**Notice of Allowability**

10/009,772

KIM, KWANG-CHUL

### **EXAMINER'S AMENDMENT**

FIG. 1A (PRIOR ART)

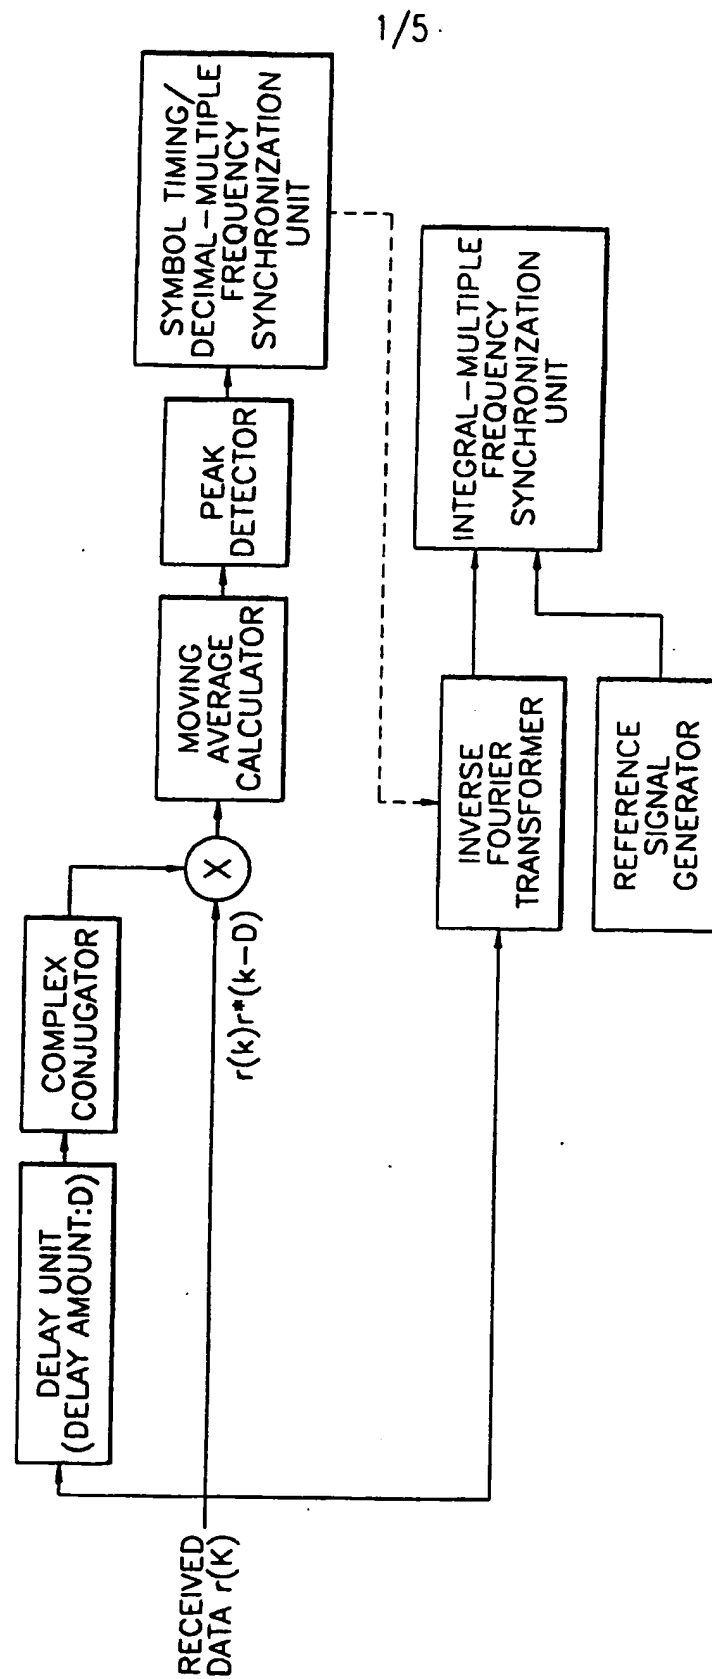
- Figs. 1A and 1B have been labeled as "PRIOR ART".
- Fig 3, step 306, has been amended to "NORMALIZE AUTOCORRELATED VALUE".
